Access Compliance Report

Public Rights-of-Way

(Curb Ramps)

Intersection ID: 51572	Main Street: FREEDOM_DR	Cross Street: WESLEY_VILLAGE_RD	Location: S
ADA ID: B1AA58248A19	Ramp Type: Perp	Initial Pass/Fail: Fail	Overall Compliance: No
		Severity Score: 8.75

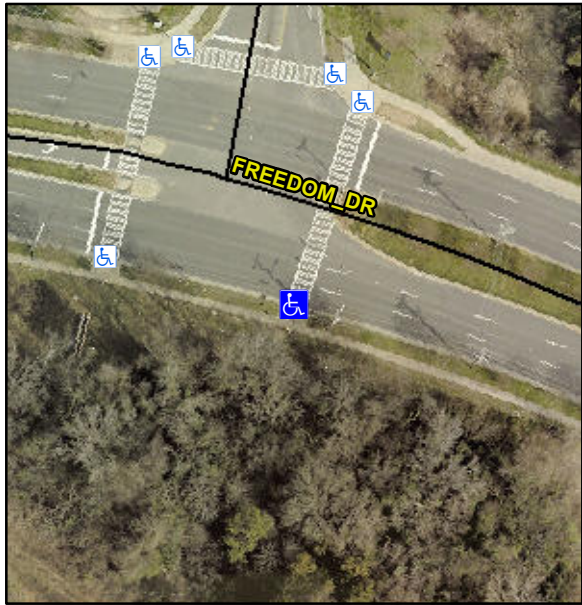
Codes/Mitigation Info/Possible Solution			Field Measurements/Component Compliance					
	Possible Solutions:		Compliance	Description	Data	Compliance	Description	Data
	Remove & Replace Entire Ramp.		N/A	Ramp Length (in)	86.0	Yes	Ramp Slope (%)	7.3
			No	Ramp Width (in)	47.0	Yes	Ramp XSlope (%)	0.4
			N/A	Flare Type LT	N/A	N/A	Flare Type RT	N/A
			N/A	Flare Slope LT (%)	N/A	N/A	Flare Slope RT (%)	N/A
			N/A	Flare Traversable LT?	N/A	N/A	Flare Traversable RT?	N/A
			N/A	Landing Length (in)	N/A	N/A	DWS Provided?	N/A
			N/A	Landing Width (in)	N/A	N/A	DWS Contrast?	N/A
			N/A	Landing Slope (%)	N/A	N/A	DWS Length (in)	N/A
			N/A	Landing X Slope (%)	N/A	N/A	DWS Full Width?	N/A
Surveyor Notes:	N/A		N/A	Landing Curb? (Y/N)	N/A	N/A	DWS Offset (in)	N/A
			N/A	Shared Landing?	N/A			
			N/A	Gutter Ponding?	N/A	N/A	Gutter Slope (%)	N/A
			N/A	Gutter Lip Ht (in)	N/A	N/A	Gutter X Slope (%)	N/A
			N/A	Painted X Walk1?	Yes	N/A	Painted X Walk2?	N/A

X Walk 1 Direction	To N		X Walk 2 Direction	N/A
			N/A	X Walk 1 Width (in)	104.0	N/A	X Walk 2 Width (in)	N/A
				X Walk 1 Slope (%)	3.7		X Walk 2 Slope (%)	N/A
				X Walk 1 X Slope (%)	0.8		X Walk 2 X Slope (%)	N/A
			N/A	Ramp inside XWalk1?	Yes	N/A	Ramp inside XWalk2?	N/A
PROW/ADA:	Not Found, R304.5.1			Road Slope (%)	N/A	N/A	Clear Space?	N/A
				Road X Slope (%)	N/A	N/A	Clear Space to XWalk (in)	N/A
			N/A	Any Obstructions?	N/A	N/A	Storm Grate/Utility Hazard?	N/A
				Obstruction Type			Storm Grate/Utility Type	
					N/A			N/A
						Yes	Surface Condition? (G/P)	Good
Total Cost:		\$	1850.00
